May 11, 2017

SUBJECT: Addendum Number 2
Old St. Paul's Evangelical Lutheran Church
Narthex Addition

FROM: Ramsay Burgin Smith Architects, Inc.
225 North Main Street - Suite 501
Salisbury, NC

SHEET NO.
MBD | .1
 OF **3**

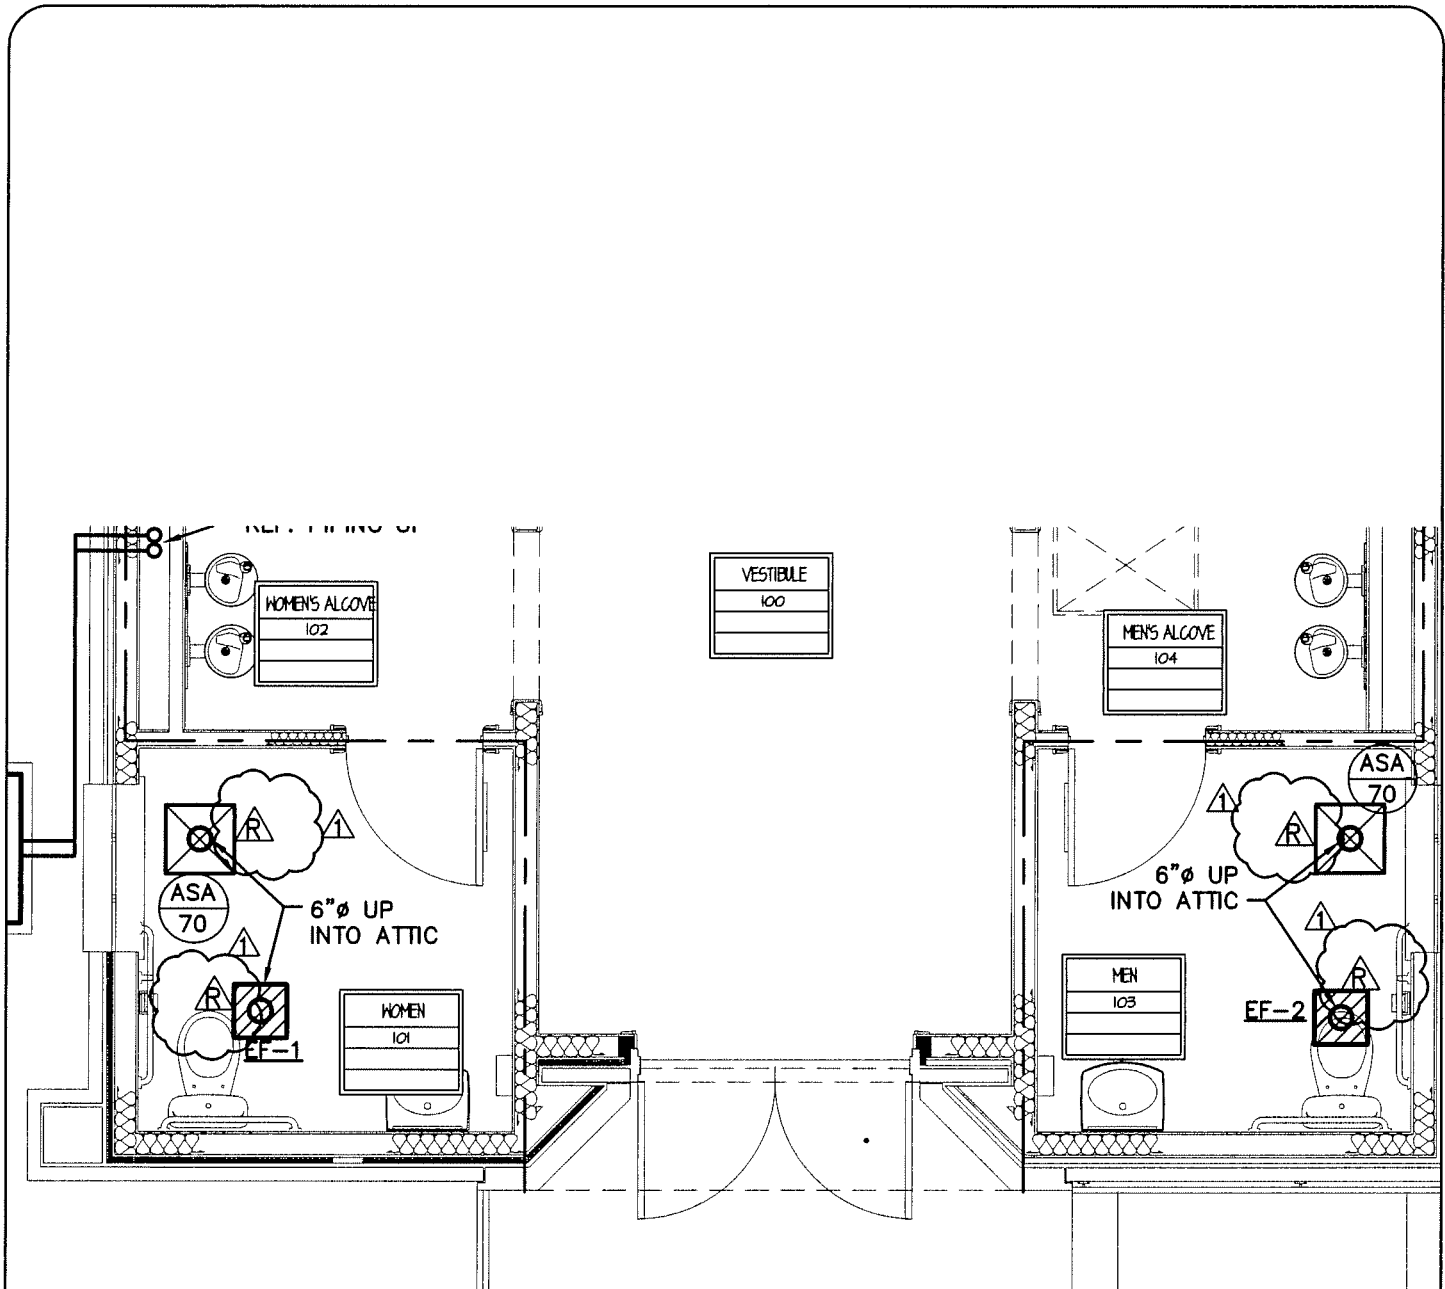
Item 11 - Reference Sheet M1 – Mechanical Floor Plans

Detail 5: Relocated Fan VF-1 to move it at least 4 feet from the 3-hour wall as illustrated in bulletin drawing MBD1.1.

Detail 5: Relocated supply diffuser serving Vestibule 100 to clear device from rated assembly as illustrated in bulletin drawing MBD1.1. (This was described in the previous Addendum#1 as Item 10)
